**BOLLETTINO TECNICO**

N° **109EP-5**

**MODELS AFFECTED :** A109E

MODIFICATION OF ENGINE EXHAUST EJECTORS P/N 109-0601-51 BY  
APPLYING THE KIT P/N 109-0822-94.

FIGURE 10

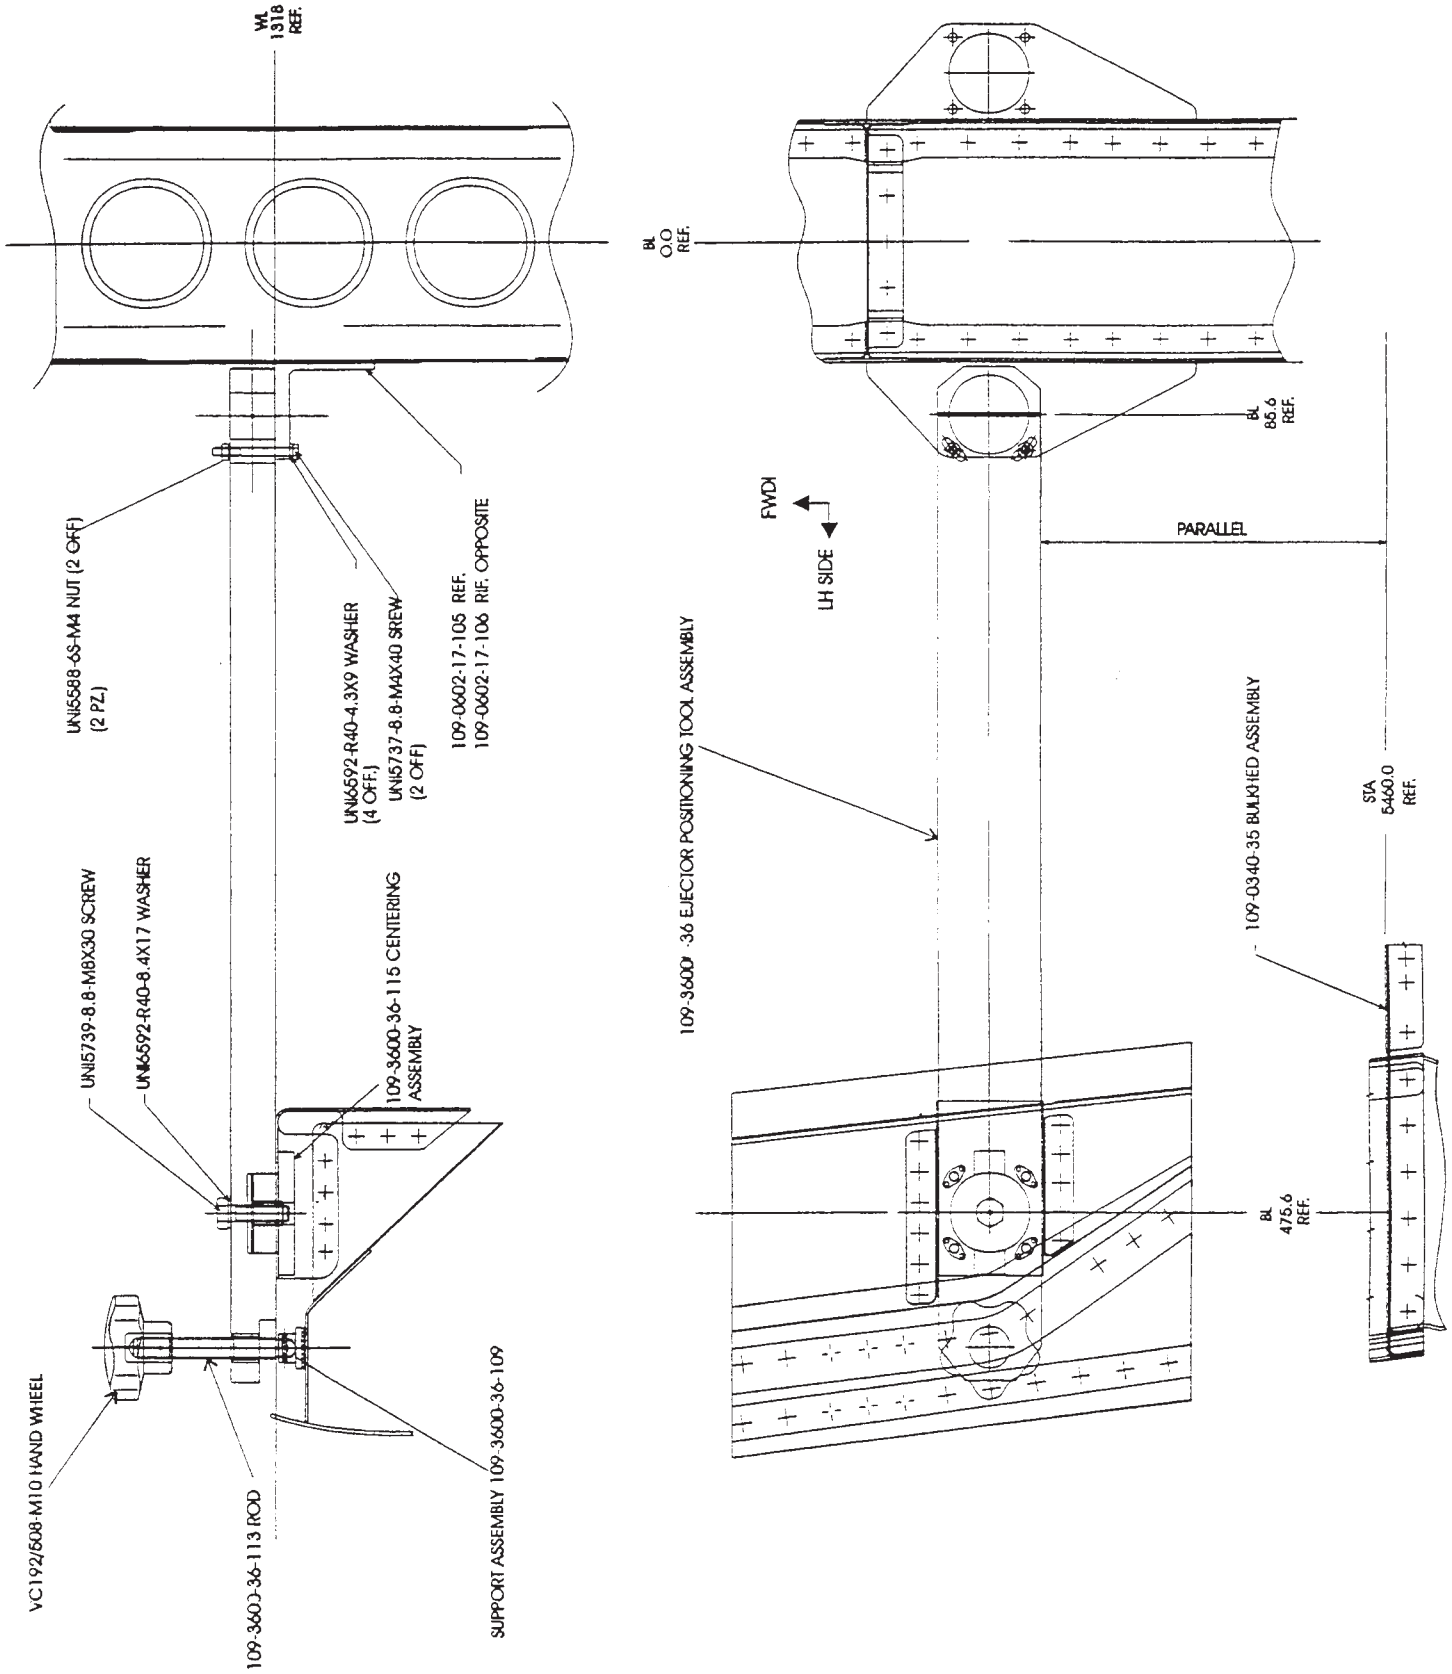
- 8.1.1. Unrivet rib P/N 109-27479-109 (LH) /-110 (RH) from brackets (refer to figure 9)
    - 8.1.2. Install tool P/N 109-3600-36-101 on support P/N 109-0602-17 as indicated in figure 10 and level it by using adjustment handle.

- 8.2.3. Fill free holes using rivets P/N M7885/2-4-02.
  - 8.2.4. Install tool P/N 109-3600-36-101 on support 109-0602-17 as indicated in figure 10 and level it by using the adjustment handwheel .  
Ensure to position tool parallel to bulkhead assy (refer to figure 9).

- 12 For helicopters that were provided with bolts to secure ejector-saddles, rework ejectors and saddles as follows:
  - 12.1. Install saddle P/N 109-0601-79-131 (LH) and 109-0601-79-132 (RH) on relative dampers, as indicated in figure 10, by using for each damper: one (1) bolt P/N NAS6604D20 one (1) washer P/N MS20002C4, one (1) washer P/N LN 9025-0610L, and one (1) bolt P/N MS 21042-4.

- eight (8) washers P/N LN 9025-0510L.
    - four (4) nuts P/N MS 21042-L08.
15. Install saddles P/N 109-0601-79-131 (LH) and 109-0601-79-132 (RH) on relative dampers, as indicated in figure 10, by using for each damper: one (1) bolt P/N NAS 6604D20, one (1) washer P/N MS20002C4, one (1) washer P/N LN9025-0610L, one (1) nut P/N MS 21042-4. Torque to 2.26 Nm.

FIGURE 11

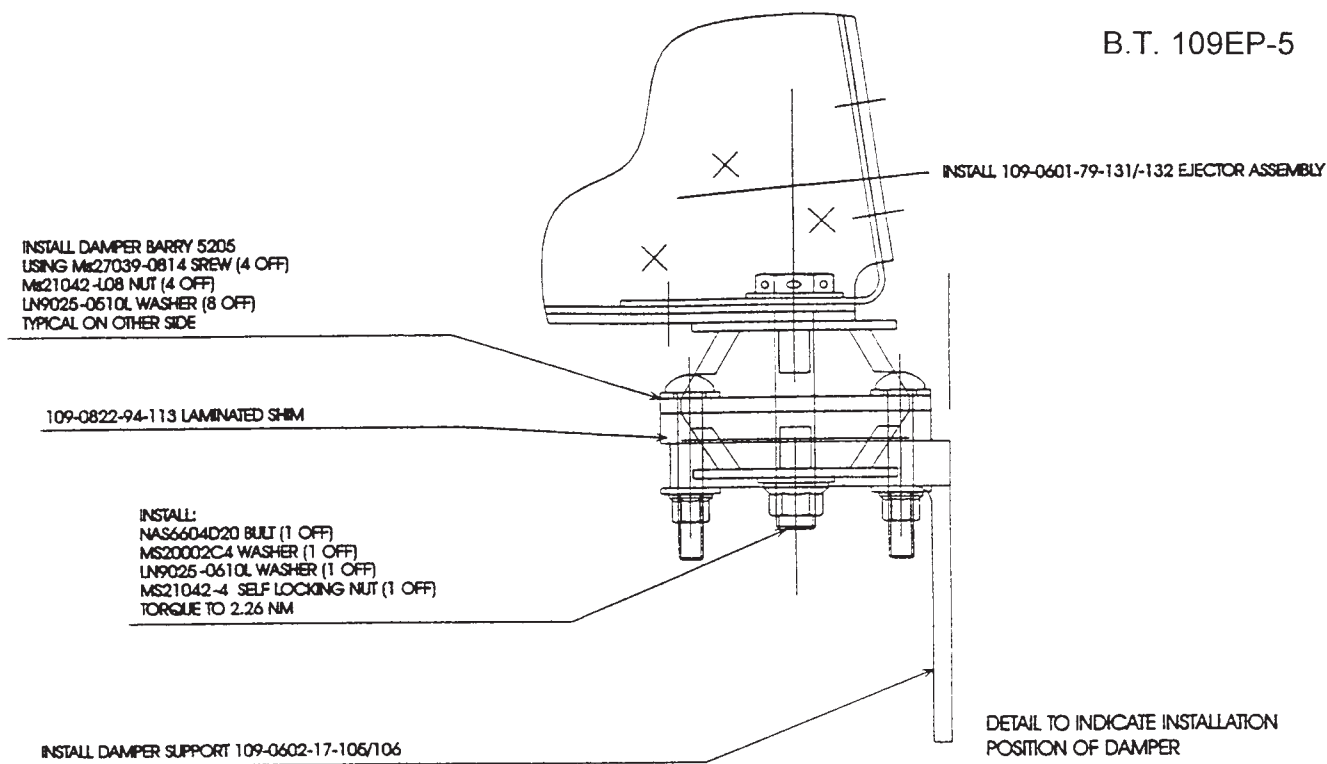
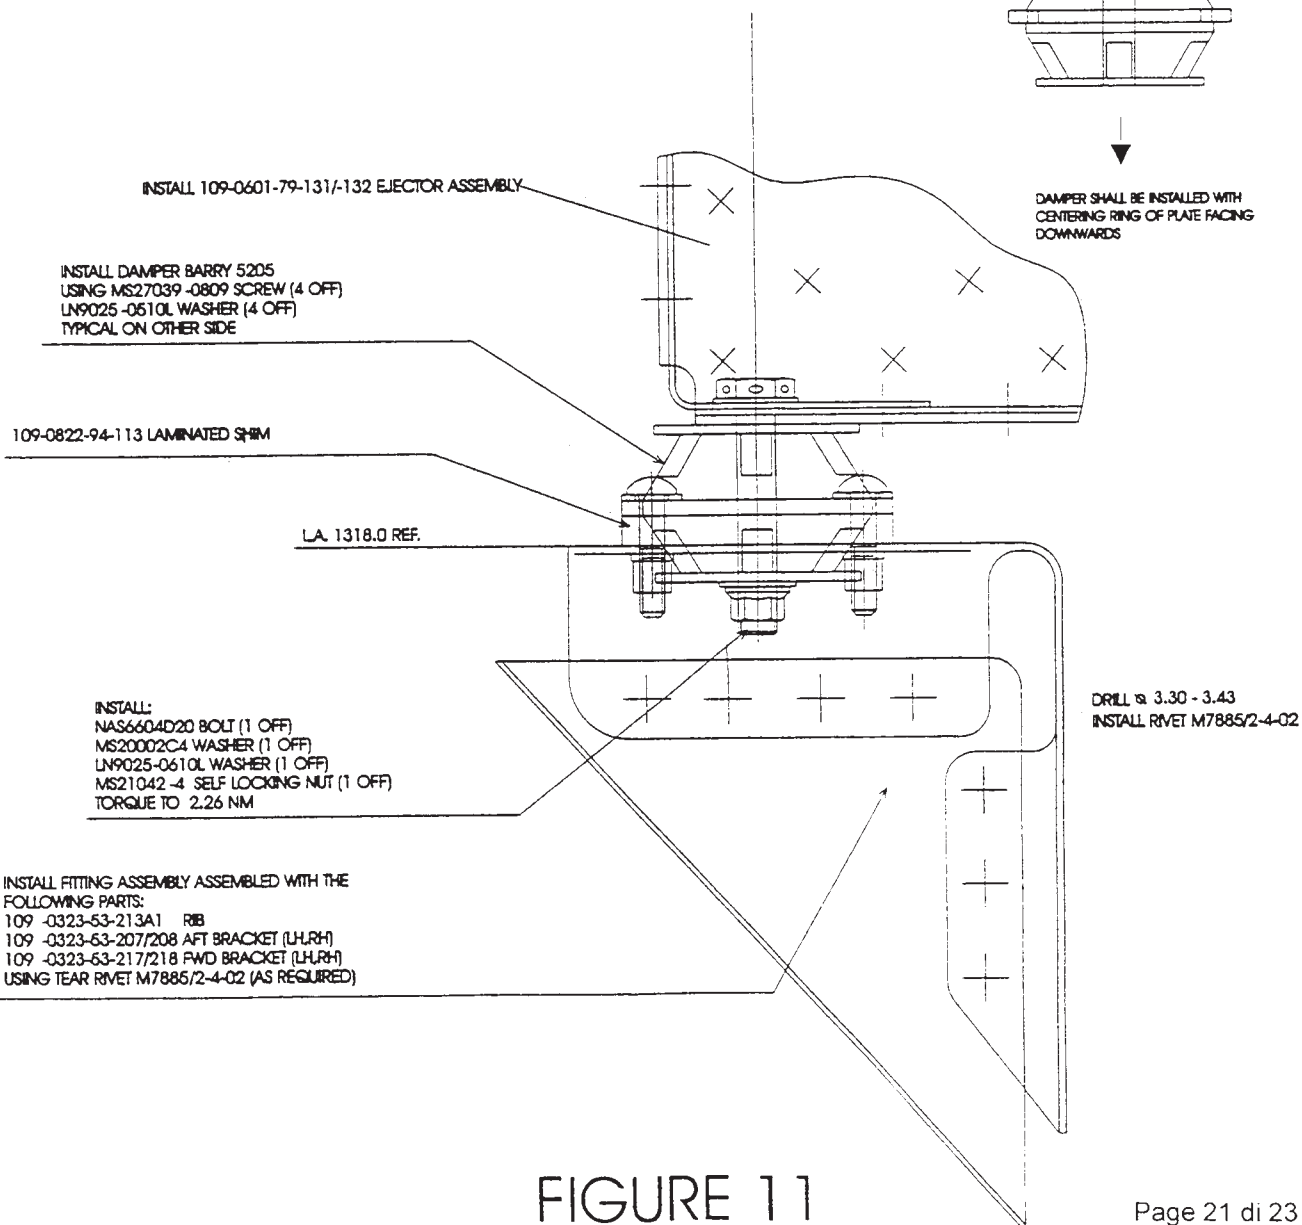
- 8.2.10 Secure rib to brackets using rivets P/N M7885/2-4-02.
  - 8.2.11 Reinstall baggage compartment upper cover.
9. Install damper P/N BARRY 5205 on support P/N 109-0602-17 and secure as indicated in figure 11 by using four (4) screws P/N MS 27039-0814, eight (8) washers P/N LN9025-0510L and four (4) nuts P/N MS21042-L08.

10. Install damper P/N BARRY 5205 on support assy and secure as indicated in figure 11 by using four (4) screws P/N MS27039-0809; four (4) and washers P/N LN9025-0510L.

Ensure that damper is installed with centering ring facing downwards as indicated in figure 11.

13. Record, if present, the vertical distance between saddle and damper.
14. If play results greater than 1 mm remove dampers and install laminated shim (peel as necessary) P/N 109-0822-94-113, as indicated in figure 11.

FIGURE 12

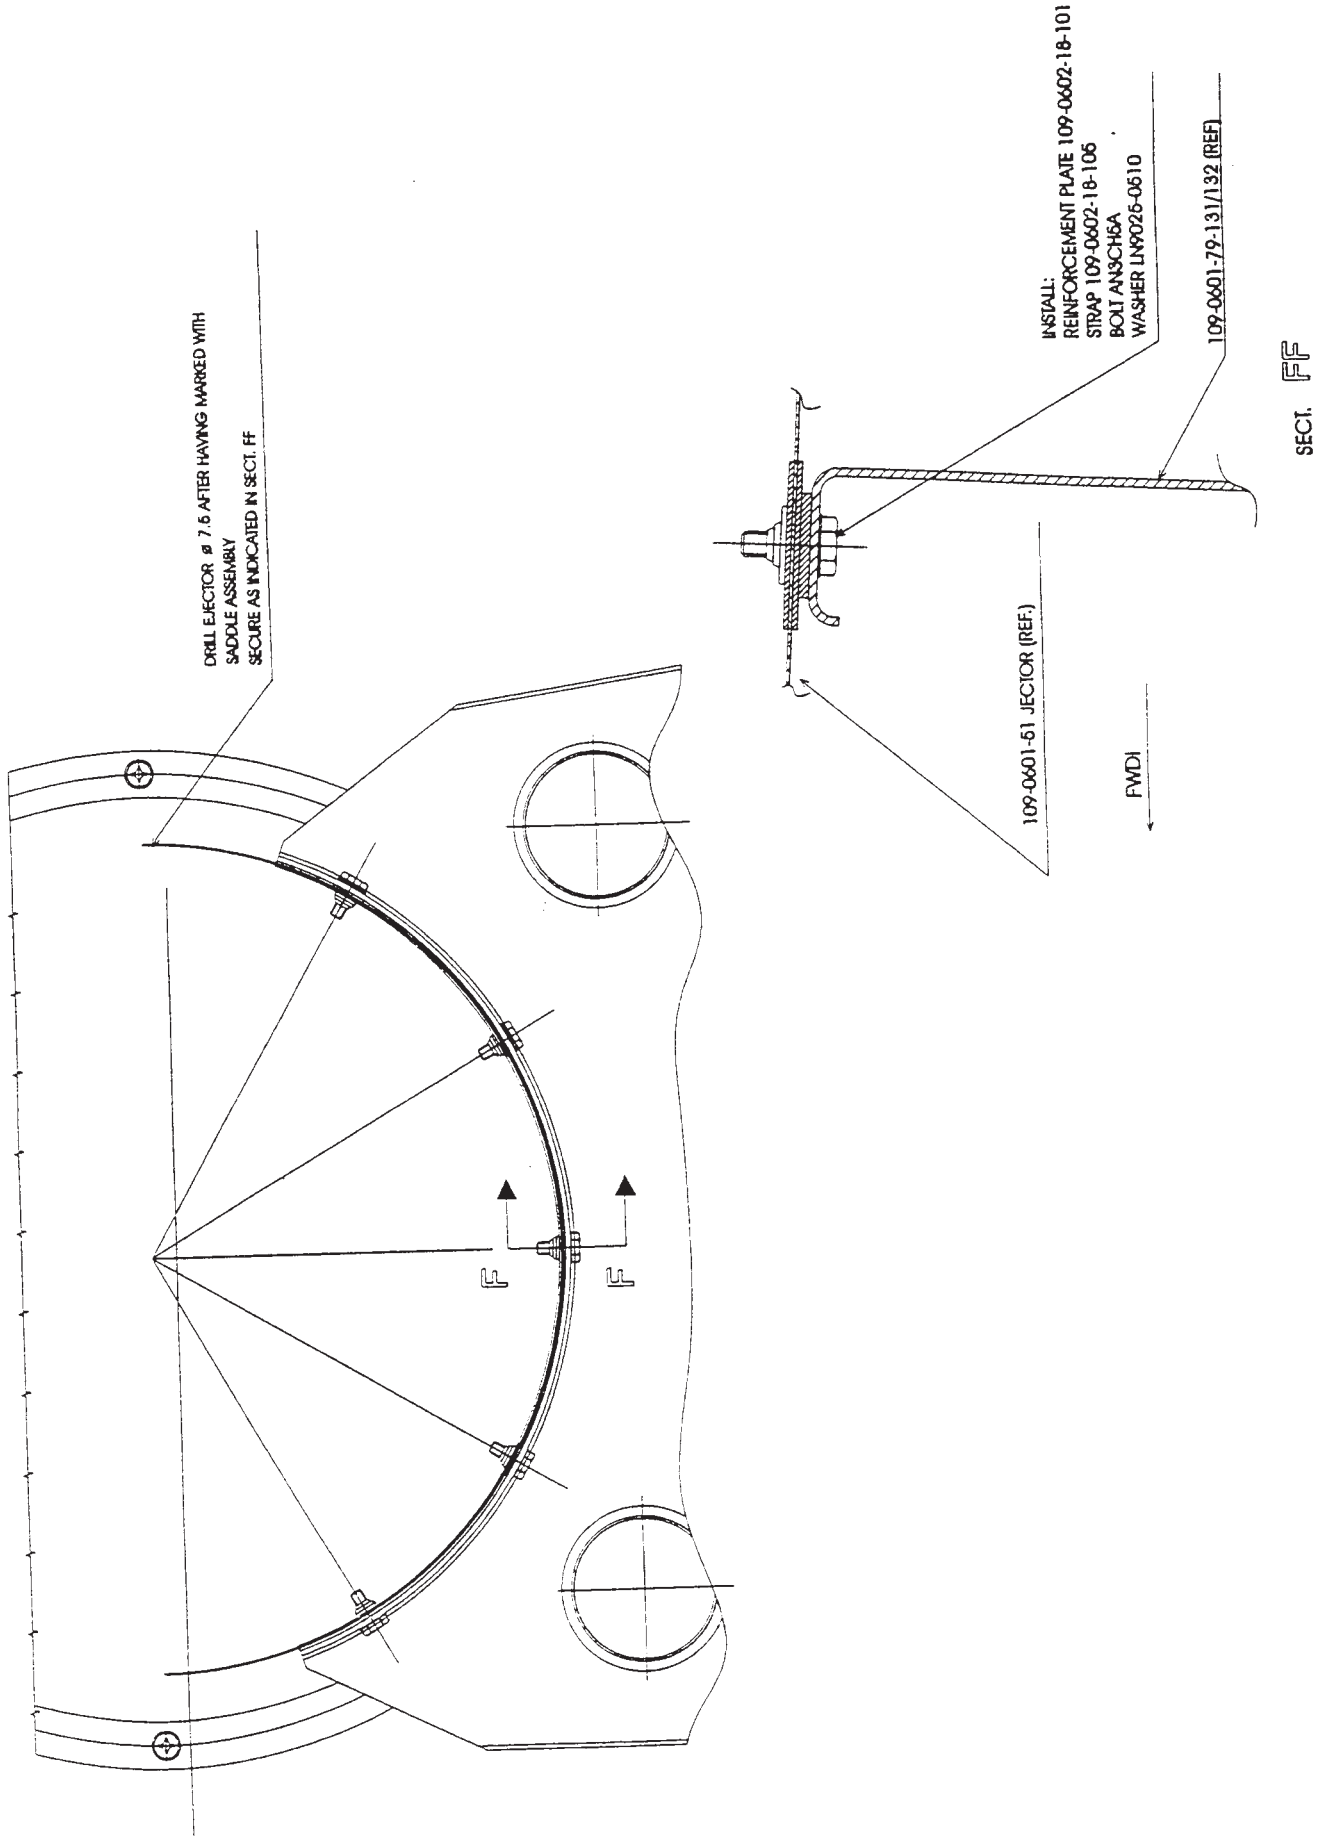
- 11.5 Drill ejector  $\varnothing$  7.5 mm as indicated in figure 12.
- 11.6 Install ejector on helicopter and secure to bulkhead, tighten using hardware previously removed.

- 11.7 Detach saddle from damper by removing associated hardware.
- 11.8 Install strap P/N 109-0602-18-105 between ejector and saddle and position reinforcement plate P/N 109-0602-18-101 inside ejectors (refer to figure 12). Secure ejector to relative saddle with five (5) bolts P/N AN3CH5A and five (5) washers P/N AN960C-10L (ref figure 12)

- 12.13 Enlarge guide holes  $\varnothing$  2.5 mm of saddle to  $\varnothing$  5.0 mm.
- 12.14 Install strap P/N 109-0602-18-107 drilled to  $\varnothing$  7.5 mm between ejector and saddle and position reinforcement assy inside ejectors.  
Secure ejector to relative saddle with four (4) bolts P/N AN3CH5A and four (4) washers P/N AN960C-10L (refer to figure 12).

FIGURE 13

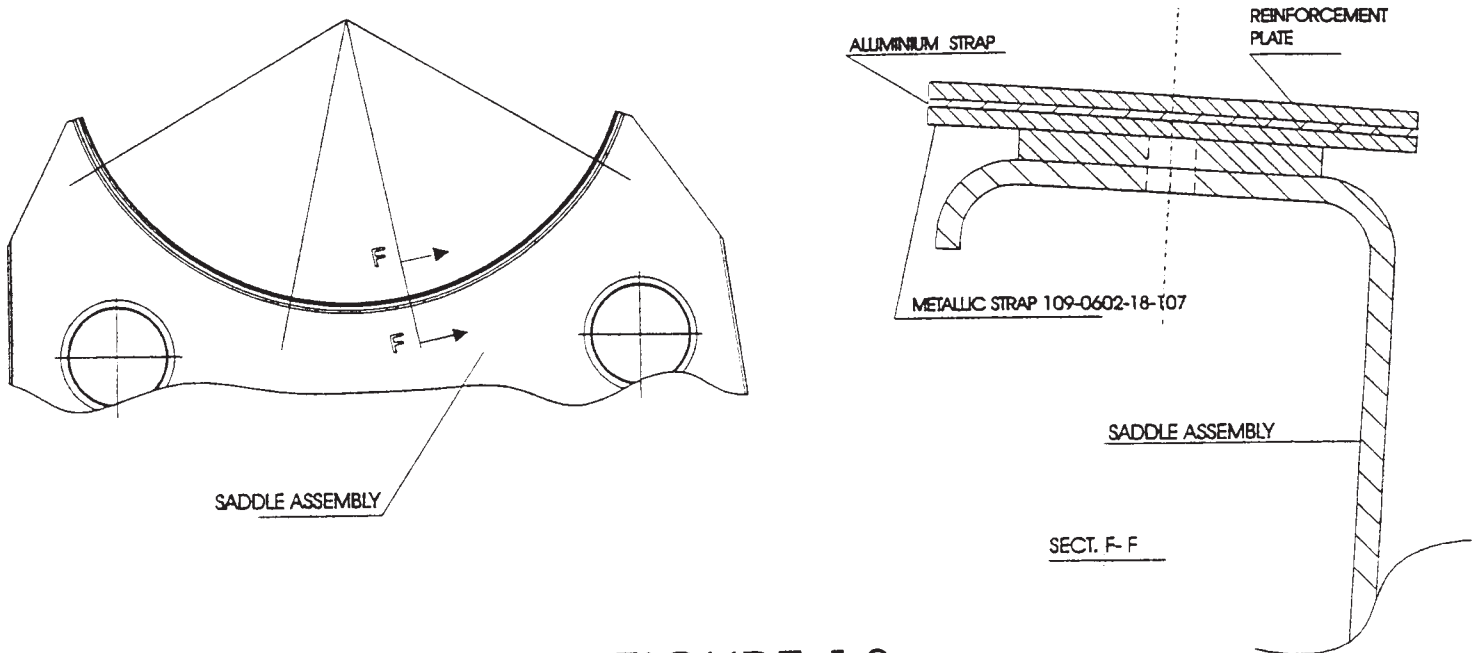
- 12.7 Install on saddle: strap drilled to  $\varnothing$  2.5 mm, fabricated aluminium strap and a new strap P/N 109-0602-18-107.  
Ensure that straps are correctly seated on saddle (refer to figure 13).

FIGURE 14

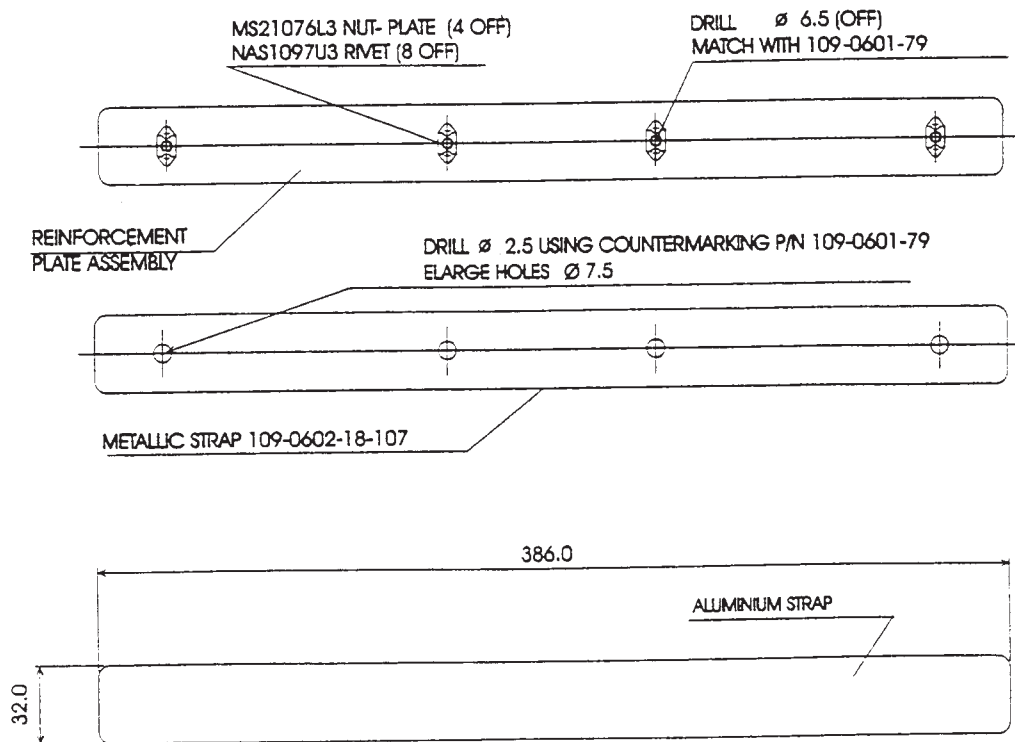
- 12.6 Fabricate a strap using aluminium to the following dimensions (refer to figure 14):
    - length 386.0 mm
    - width 32.0 mm
    - thickness 6.4 mm

- 12.9 Remove upper strap, (reinforcement plate) and enlarge holes to  $\varnothing$  6.5 mm, countermark by using nut-plates P/N MS 21076L3 and drill holes  $\varnothing$  2.49 to 2.59 mm in order to be riveted afterwards (refer to figure 14).

- 12.10 Secure nut plates with four (4) rivets P/N NAS1097U3-3 to obtain reinforcement assy (refer to figure 14).
- 12.11 Remove aluminium strap.
- 12.12 Enlarge guide holes  $\varnothing$  2.5 mm of strap P/N 109-0602-18-107 resting against saddle to  $\varnothing$  7.5 mm (refer to figure 14).
